SUBJECT: CALLAWAY PLANT, UNIT NO. 1 – REGULATORY AUDIT PLAN AND SETUP OF ONLINE REFERENCE PORTAL FOR LICENSE AMENDMENT REQUEST AND EXEMPTION FOR FUEL TRANSITION TO FRAMATOME GAIA FUEL (EPID L-2022-LLA-0150 AND EPID L-2022-LLE-0030)

### **REGULATORY AUDIT PLAN**

#### TO SUPPORT REVIEW OF LICENSE AMENDMENT/EXEMPTION REQUEST

### FOR FUEL TRANSITION TO FRAMATOME GAIA FUEL

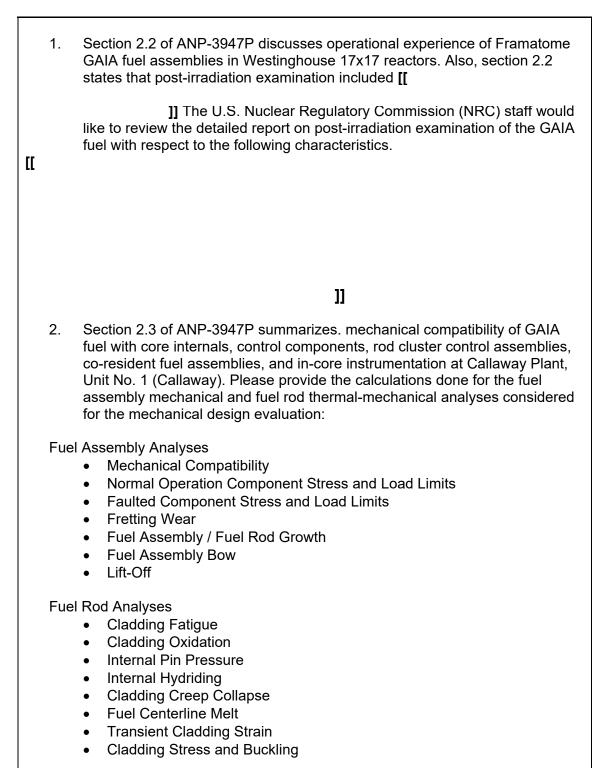
Provide a chronology of the various fuel designs in the Callaway core design (GAIA and co-resident Westinghouse fuel design) starting from Callaway operating cycle 27, including the planned introduction of GAIA in batch sizes transition cycles and equilibrium cycle.

Fuel pellet diameter for GAIA fuel is about 7 percent larger than the co-resident Westinghouse fuel (0.3225 inch versus 0.3008 inch). Is there a corresponding change in the Uranium-235 (U-235) weight in GAIA fuel design. If yes, what is its impact on core design and energy requirements.
